Subject: A6 to Manchester Airport Relief Road - Report on the Outcome of the First Phase of Consultation and Emerging Preferred Scheme.

Report to Executive Meeting

Date: 2 April 2013

Option 1: Traffic lights controlled cross roads over airport spur rail lines.

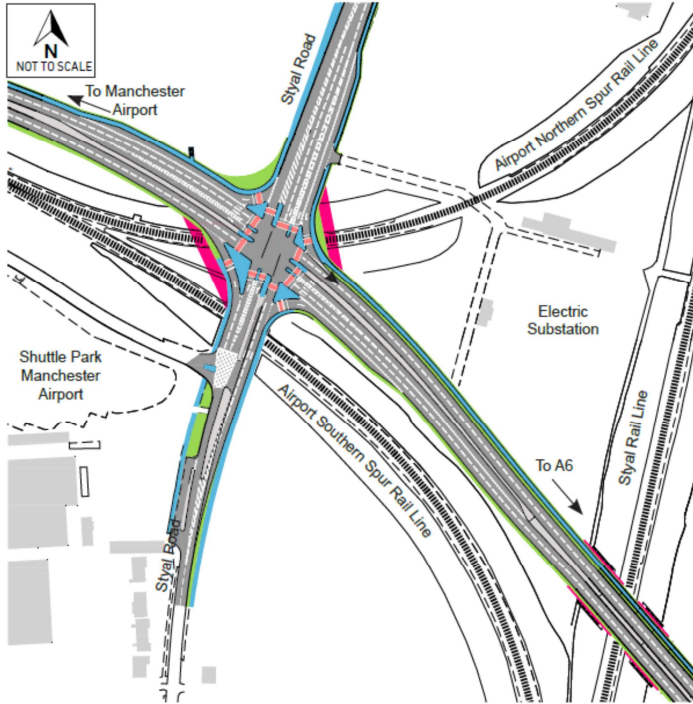
- There was concern and a lack of support for this option as the new road would not be screened from some existing properties; and
- A request was made that consideration should be given to increasing and extending any bunding as far as possible, particularly south of the Airport Spur Line, in order to screen the road from Styal Road residents.

- Concern that the positioning of this junction above the two spurs of the railway line into the airport would in the result of a serious accident involving a HGV which may fall onto the rail line;
- Concern about loss of rare vegetation as a result of this junction option.

- Incorporate option 1 into the emerging preferred scheme layout plans.
- Further traffic modelling work will be carried out to ensure the requisite the traffic capacity is provided via minor alterations to the layout.
- The design has also been refined to reduce the level of the dual carriageway deeper into the ground by approximately 1.5m on the eastern approach near to the Styal Rail Line to mitigate the visual impacts of the road.
- Consideration of additional bunding and /or noise fencing

Option 2: Traffic lights controlled cross roads to the north of the airport spur rail line.

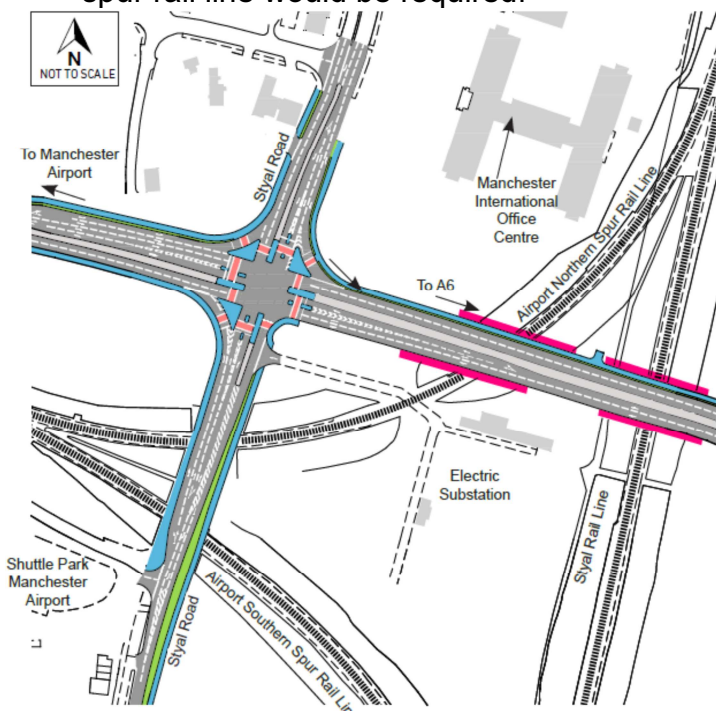
- **LLF 12. Moss Nook - Styal Road**
- Throughout the course of discussions, it was evident that option 2 was the preferred junction arrangement particularly for those residents of Styal Road who attended the forum. The main reason was the potential improved screening of the new road that can be provided with option 2.

- Residents would like to see bunding extended as far as possible, particularly to the west of the rail line;
- This option minimises the disruption to Styal Road residents and as a result was the preferred junction arrangement;
- This option is future-proofed, giving the potential for widening in future if required; and
- Trees should be planted on the bund tops and slopes as fencing was not considered to be sufficient, or acceptable, for screening.

- Safety concerns about introducing a traffic signal controlled junction with Styal Road, a junction with on and off slip roads considered to be a safer option.

Option 2: New cross roads with traffic lights.

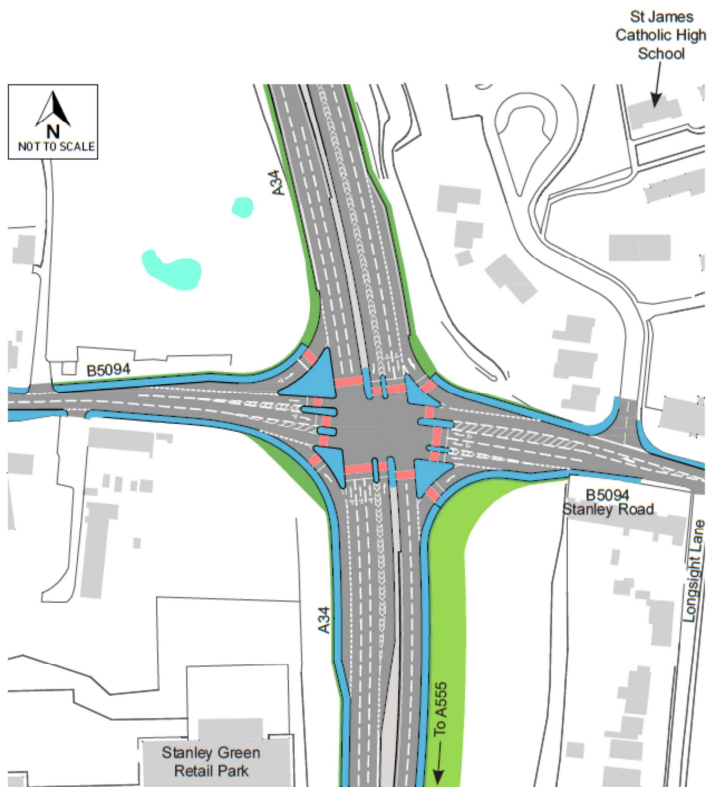
- Consider introducing a pedestrian/ cycle bridge for a safer crossing.

Option 1: Scheme passes under a realigned Woodford Road with new traffic lights controlled junction introduced.

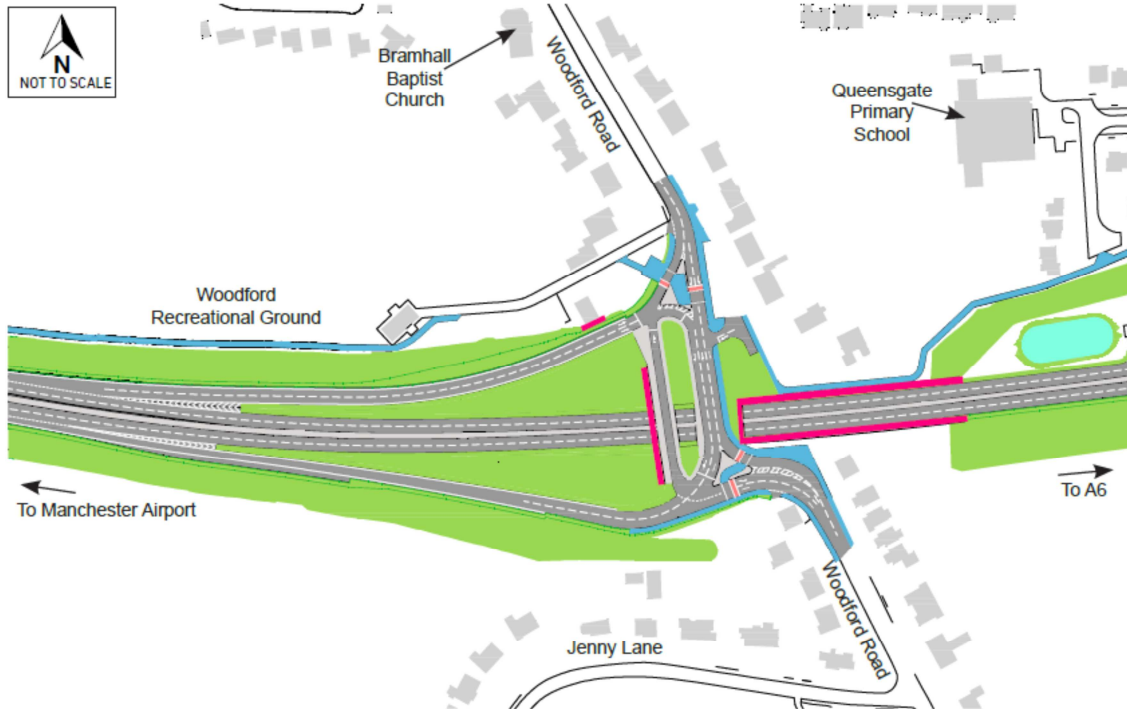
- Impact of the road in terms of noise and visual intrusion would be reduced if the road was at a lower level and Woodford Road Bridge not raised above ground level;
- Noise bunding should be extended as far as possible and be as high as possible to minimize impact on residents. However, safety and security issues with access to rear gardens have to be carefully thought out;
- Reduce the size of this junction if possible;
- Remove traffic signals and retain roundabout junction;
- Restrict access for HGVs on local roads; and
- Move the junction to the east to reduce its impact on residents.

- Comments specific to Option 1 included:
 - This option is more problematic for HGVs, particularly on the approach from Woodford towards Bramhall;
 - Preference for a pedestrian bridge rather than an at grade crossing point.

Option 2: Scheme passes under Woodford Road with new traffic lights controlled junctions introduced.

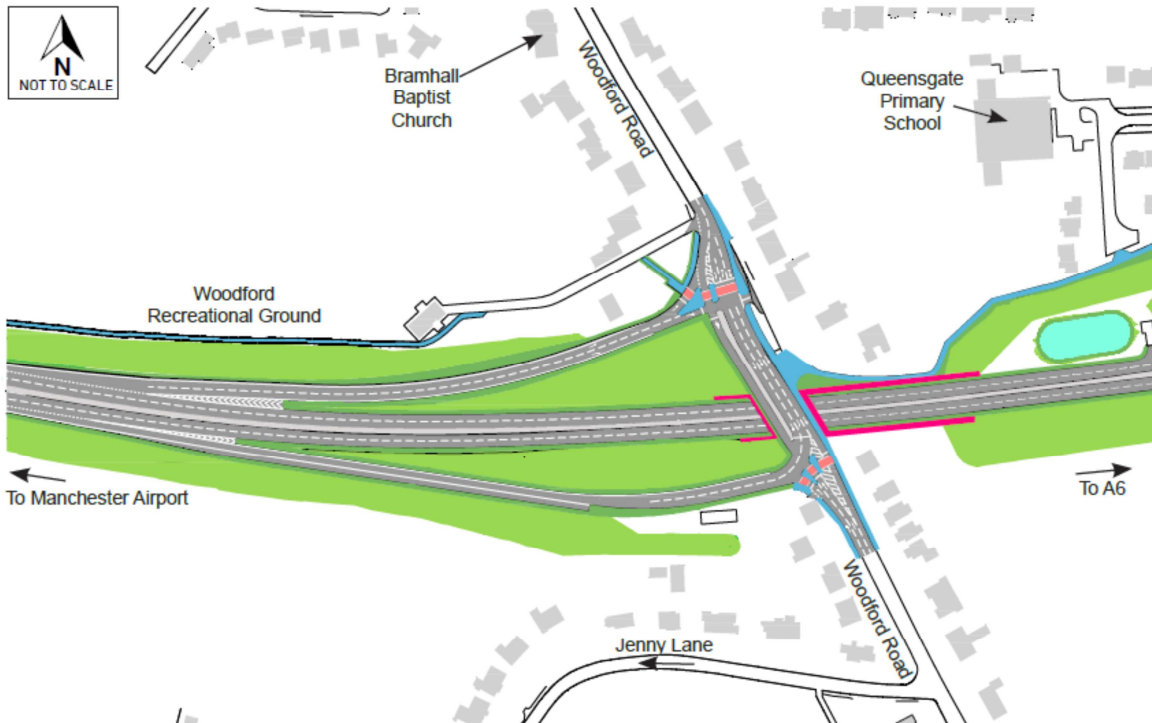
- Traffic lights will increase noise and air pollution for those living close to the route;
- Straightforward cross roads would be preferred;
- The road should go under the rail line; and
- Trees should be planted on the bund tops and slopes.

- Comments specific to Option 2 included:
 - Considered to be the best option for HGVs but amendments should be made to the pedestrian crossings to provide suitable widths for HGVs;

- Access to the residential access service road should be moved north.

- Incorporate option 2 into the emerging preferred scheme layout plans.
- The location of the attenuation and treatment ponds have been relocated to the south of the relief road which provides the further room for mitigation including landscaping for residents to the north of the relief road.
- Additional environmental screening bunds and acoustic fencing are being included to further mitigate the effects of noise and air quality impacts. This is also in liaison with Queensgate Primary School LLF.

Option 1: Scheme connects to Chester Road via a new short link road. The scheme has a large traffic lights controlled roundabout junction.

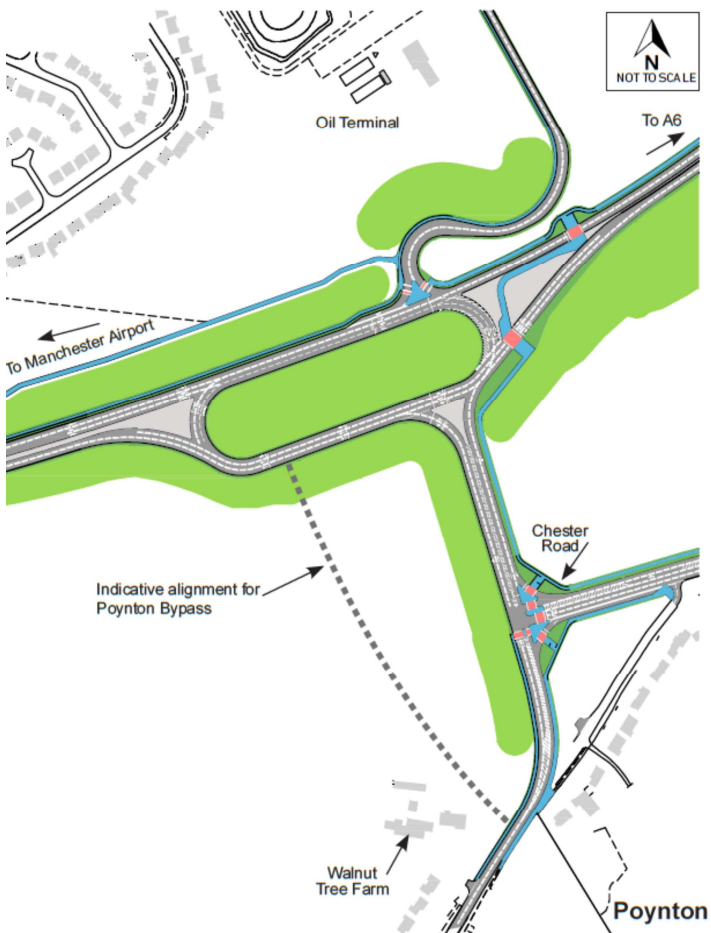
- The SUDS ponds should be relocated to the south of the proposed Scheme if possible and associated drainage would drain away from the residential area;
- The Scheme should be located as far away from the school as possible;
- The existing public right of way should be separate from the road;
- Residents would prefer to have a bridge rather than pedestrian crossings at the junction;
- The cycle route should be moved away from the residential properties; and
- Traffic signals would mean vehicles stopping and starting which would result in increased noise.
- Pollution and congestion in this area.
-

- Further detailed analysis is required in order to determine the optimum proposal at this location including further traffic modelling work to ensure the requisite traffic capacity is provided via slight alterations to the layout. This will also ensure that the Poynton Bypass can be accommodated in the future.
- Additional environmental screening bunds and acoustic fencing have been developed further at this location. These proposals and principles could be applied to either junction option.

Option 2: Scheme connects to Chester Road via a new short link road. The scheme has a traffic lights controlled cross roads junction.

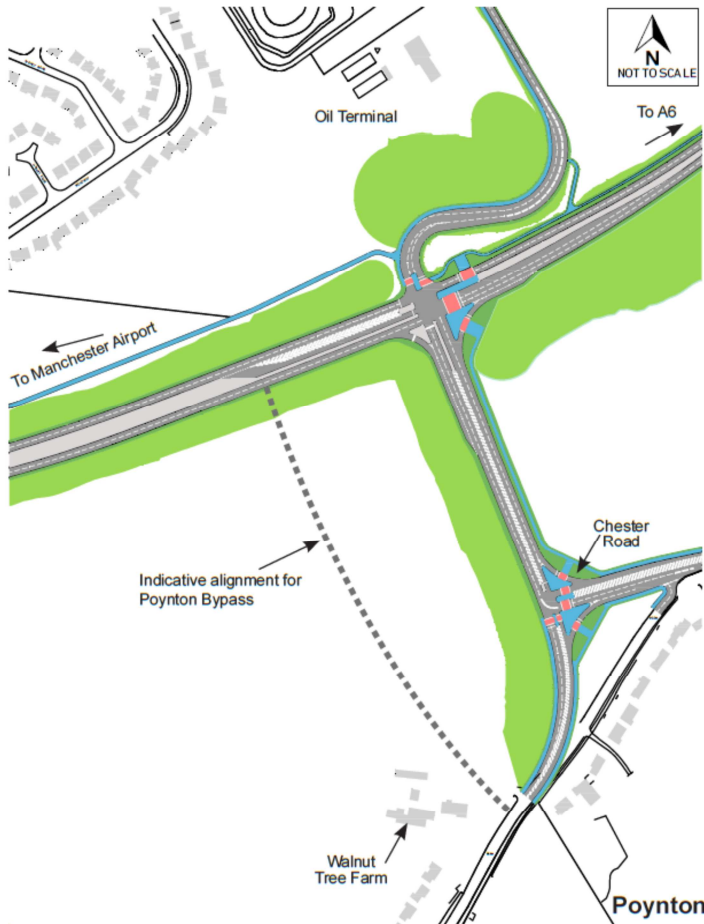
- The junction design would create greater levels of congestion in the area as the traffic light signals would prevent free flowing traffic along the route; and
- Traffic lights will increase noise and air pollution for those living close to the route.

Option 1: Scheme passes under a new bridge for Woodford Road.

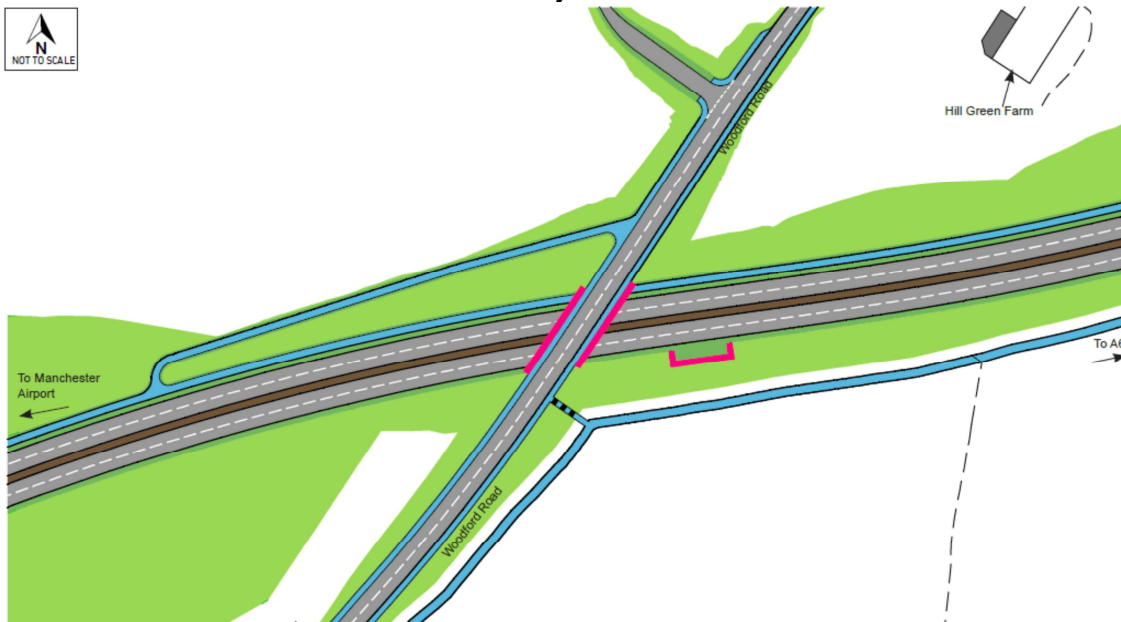
- The view that the road should be in a deeper cutting;
- The request for a footpath from Doghill Farm to the bridge over Woodford Road;
- Provision of noise and visual mitigation should be maximised; and
- The Scheme should be moved as far as possible from properties on Woodford Road.

- The scheme at this option should be deeper in cutting;
 - A footpath is required from Dog Hill Farm to the new overpass at Woodford Road;
 - The footpath should be extended to include the existing railway bridge.

- Incorporate option 1 into the emerging preferred scheme layout plans.
- Additional environmental screening bunds and acoustic fencing have been developed at this location.

Option 2: Woodford Road connects to the scheme via two traffic lights controlled, staggered T-junctions.

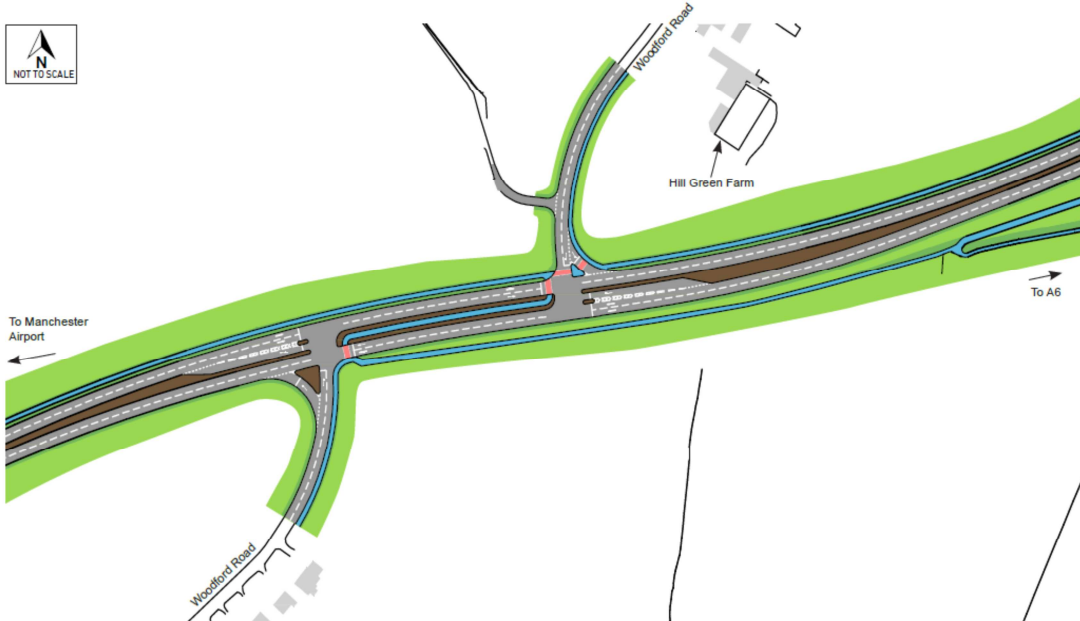
- Road safety concerns when accessing the road from Mill Hill Hollow Road; and

- Concern that the junction will increase accidents, create crime issues by improving access to the area and worsen congestion.

- Comments specific to Option 2 included:
 - The option appears to be dangerous;
 - The junction will interrupt traffic flow on Woodford Road;
 - The junction will put pedestrians and cyclists in danger as there is no provision for these road users on Woodford Road.

Option 1: Traffic lights controlled cross roads.

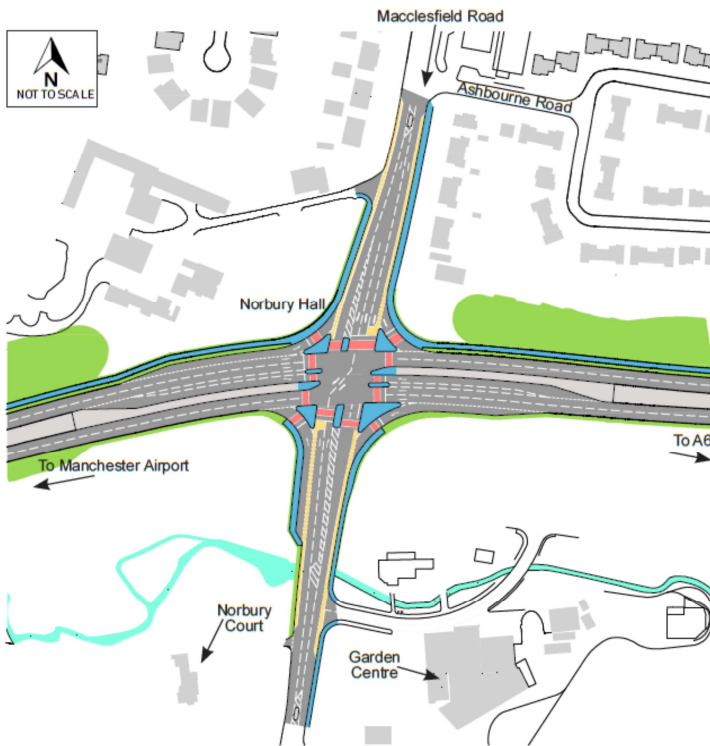
- Due to its location, the junction will have a significantly greater visual and noise impact with regards to surrounding houses;
- The junction design would create greater levels of congestion in the area as the traffic light signals would prevent free flowing traffic along with route;
- The road should be in cutting and the height of the road reduced as much as possible adjacent to residential properties;
- The option would cause increased air pollution, with concern that the prevailing wind would spread pollution to properties to the north;
- The junction design would cause a significant delay for vehicles travelling onto the new road from Macclesfield Road;
- Concerns about the impact of the junction on the Fiveways area and bus terminus; and
- Extensions to the bunding area were requested.

- The junction is too large and therefore will have a greater visual, noise and pollution impact on all adjacent properties;
- Due to its location, the junction will have a significantly greater visual and noise impact with regards to surrounding houses;
- The junction design would create greater levels of congestion in the area as the traffic light signals would prevent free flowing traffic along with route;
- The junction design would cause a significant delay for vehicles travelling onto the new road from Macclesfield Road; and
- Extensions to the bunding area are needed.

- Preference for option 1 at this location; and
- Concerns were raised about rat running on Anglesey Road and South Park Road during construction.

- Preference for this option was expressed due to reduced land take and reduced impact on local properties;
- Visual and noise impact should be minimised;
- Landscaping and fencing required to mitigate noise and visual impact; and
- Bunding and landscaping the south side of the Scheme should be introduced.

- Comments specific to Option 1 included:
 - Traffic lights would need to be linked to those at the Fiveways junction;
 - The junction is complicated and difficult for pedestrians to cross;
 - The junction is located too close to the Fiveways junction;
 - The junction is too large for the area;
 - The junction could make access to Norbury Hall dangerous.

- Incorporate option 1 into the emerging preferred scheme layout.

- Consideration for the re-alignment of the relief road being further south to maximise the distance between the relief road and the residential properties on Darley Road and Ashbourne Road. The junction configuration remains the same, however, the existing culvert may require to be widened at Norbury Brook.

- The relief road is also now deeper and is approximately 1.0m lower in the ground at Old Mill Lane and towards Macclesfield Road. The relief road ties in to Macclesfield Road as previously in terms of road level.

- Additional environmental screening bunds and acoustic fencing have been developed at this location.

Option 2: Link road connection between Macclesfield Road and the scheme.

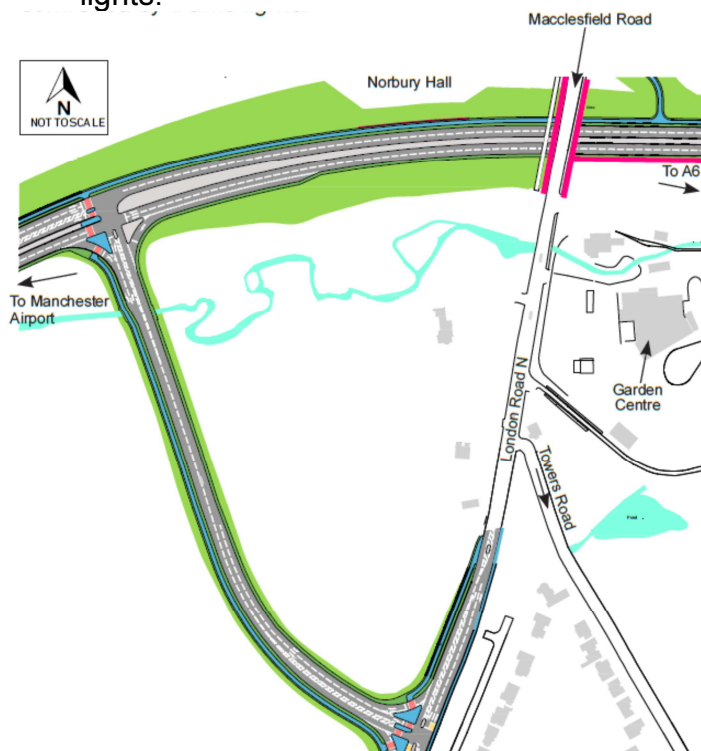
- Concerns were expressed about the impact of this larger junction on the surrounding area;
- There was a general consensus that this junction option would allow for more free flowing traffic to pass through the area and on the connecting Macclesfield Road;
- The depth of the cutting should be increased;
- A request was made for the road to be moved to be equidistant between the boundaries of house on Darley Road and Norbury Brook;
- Suggestions were made that the junction with London Road North should be a roundabout as opposed to a T-junction;
- It was suggested that the hedgerow at the end of Sheldon Road needs to be reinforced and enlarged with a greater number of shrubs and trees; and
- Requests were made for the extent of bunding provided to be increased as much as possible to minimise the noise and visual impact of the Scheme.

- It was suggested by several attendees that the junction could be moved further west (towards Manchester Airport) in order to increase its distance from surrounding houses;
- There was a general consensus that this junction option would allow for more free flowing traffic to pass through the area and on the connecting Macclesfield Road;
- It was suggested that the hedgerow at the end of Sheldon Road needs to be reinforced and enlarged with a greater number of shrubs and trees; and
- Requests were made for the extent of bunding provided to be increased as much as possible to minimise the noise and visual impact of the Scheme.

- A comment was made as to why the junction with London Road North is not opposite the Towers Road junction;
- Concerns were raised about the impact this option would have on the area in terms of landscape, ecology, noise and light pollution;
- The view was held that this option would create congestion in the area and would affect Hazel Grove and Poynton;
- There were concerns that the disruption caused by this junction would affect business in Poynton;
- Requests were made for additional bunding along the option, particularly at the London Road North junction and from 54 to 84 London Road North;
- Attendees were opposed to this option as the spur to London Road North would split an area of green space; and

- Although most attendees supported option 1, support for option 2 was expressed due to it being in cutting and the simplified junctions;
- Concern about congestion in Poynton as a result of this option;
- Comment that this option will have a greater environmental impact, including in terms of noise;
- Concerns that farm land is being split up and making it unusable;
- Concern that the land will get in-filled with development; and
- Comment that this option will affect more residential properties.

- Comments specific to Option 2 included:
 - The junction will make the use of the Towers Road junction more difficult and potentially dangerous;
 - Introduce a roundabout rather than a signalised T-junction at the London Road North junction;
 - The link road from the scheme to London Road North should be moved to the north and west;
 - The scheme is in cutting close to Norbury Brook which could present flooding issues.
